HISTORIC DISTRICT COMMISSION ADDITIONAL INFORMATION REQUEST

Application Number: HDC2025-00230

NAME: Nathan Brown		COMPANY NAME: Polymath Development	
ADDRESS: 2647 Michigan Ave	CITY: Detroit	STATE: MI	ZIP: 48216
PROJECT ADDRESS: 1039 Seyburn			
HISTORIC DISTRICT: West Village

1039 SEYBURN

A5.1

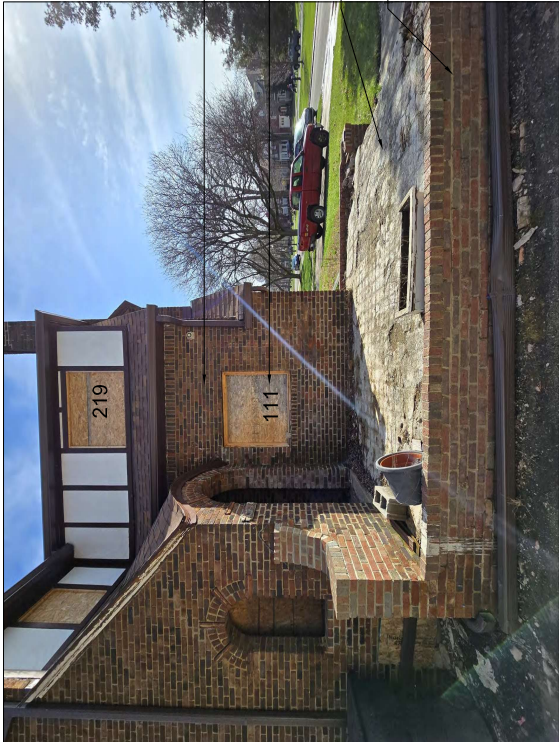
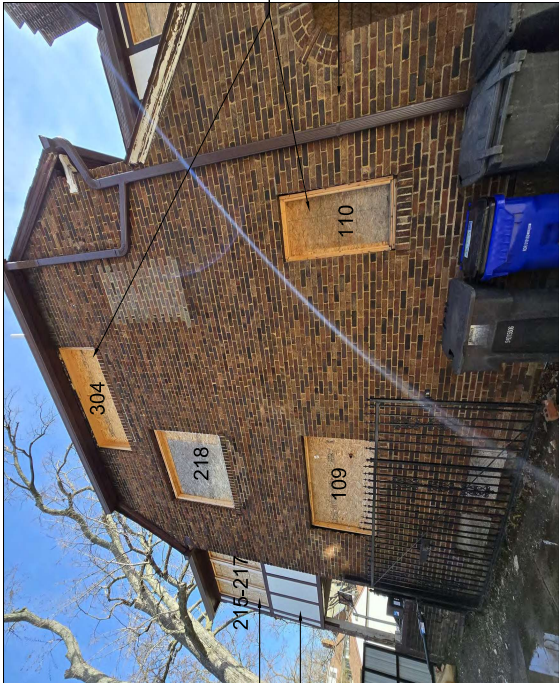
- Please provide a window schedule for the proposed new units which indicates the specific location of each new window on the building's exterior walls and dormers. Please see the attached documents as a go-by. Specifically, see the marked up photos on pages in the .01 doc and the associate schedule on the .02 doc and model your window schedule on this document

Window	Quantity	Location	RO Width	RO Height	Elevation	Type	Ext. Trim	Remarks
W101	2	Living Room	26	76	Front	Double Hung	Brickmould	Match Existing
W102	1	Living Room	48	76	Front	Fixed	Brickmould	Match Existing
W103	5	Family Room, Foyer, Den	28	76	Front/Side	Double Hung	Brickmould	Match Existing
W104	1	Dining Room	28	76	Rear	Double Hung	Brickmould	Convert to 5' x 6' 8" French Door
W105	1	Old Bathroom	32	35	Rear	Double Hung	Brickmould	Brick Infill
W106	2	Kitchen, Dining Room	30	76	Side	Double Hung	Brickmould	Convert to 60x76 Double Double Hung
W201	2	Primary Bedroom Front	26	68	Front	Double Hung	Brickmould	Match Existing
W202	1	Primary Bedroom Front	48	68	Front	Fixed	Brickmould	Match Existing
W203	2	Primary Bedroom Front WIC & Primary Bath	24	64	Front	Double Hung	Brickmould	Match Existing
W204	6	Rear, Middle, Rear Primary Bedrooms & Hall Bath	28	68	Side/Rear	Double Hung	Brickmould	Match Existing
W205	1	Rear Primary Bedroom WIC	24	48	Rear	Double Hung	Brickmould	Match Existing

W301	2	Front Gable	28	36	Front	Double Hung	1x4	Match Existing
W302	2	Front Dormer	24	36	Front	Double Hung	1x4	Match Existing
